SPR EA1N and EA2 PROJECTS

DEADLINE 6 – COMMENTS ON EAST ANGLIA ONE OPERATION PHASE NOISE MONITORING REPORT SUBMITTED AT DEADLINE 5

Interested Party: SASES **IP Reference Nos.** 20024106 and 20024110

Date: 24 February 2020

APPENDIX 2

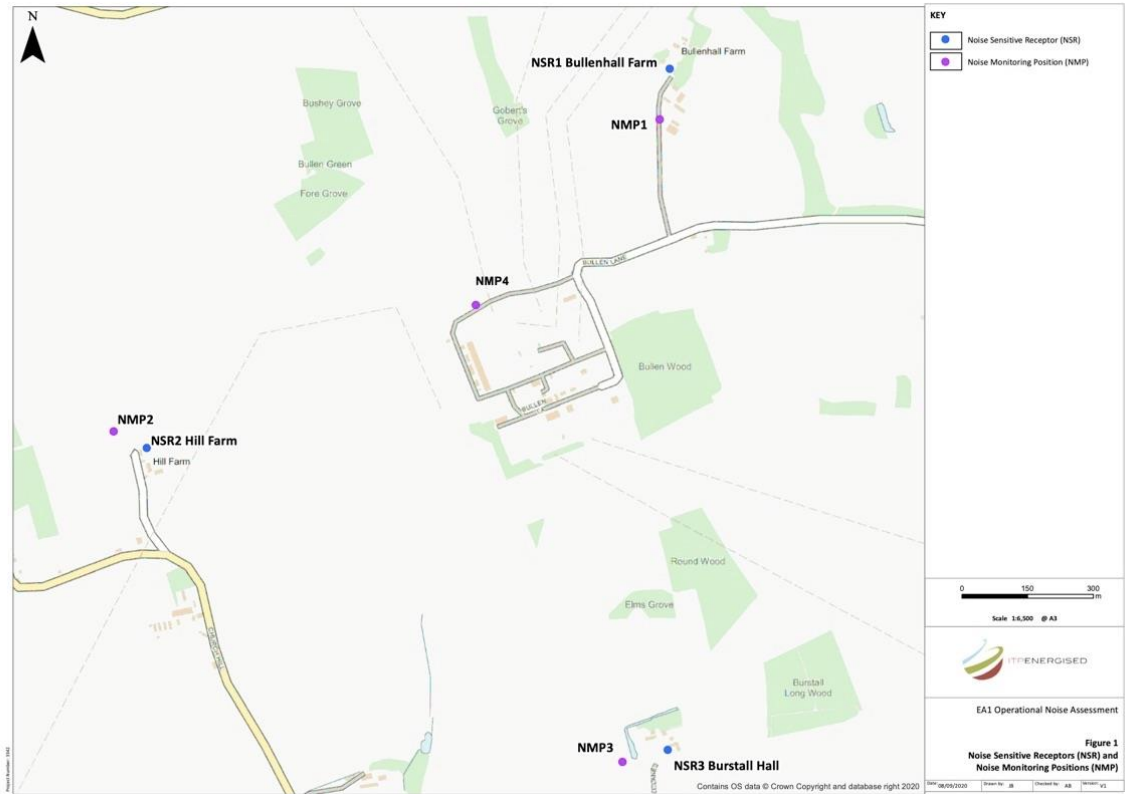
20. The plan attached to the EA1 Report (reproduced at Appendix 2 below) shows the location of the three receptors. This plan is unhelpful as it does not show the position or layout of the EA1 substation at Bramford. What is more informative is Figure 26.2 from the EA1 Environmental Statement which is reproduced at Appendix 2 below accompanied by the relevant link.
21. These plans show that the monitoring points for EA1 are 600m to 1200m from the EA1 substation whereas those proposed for Friston are approximately 250m from the substations, with the village of Friston in close proximity.
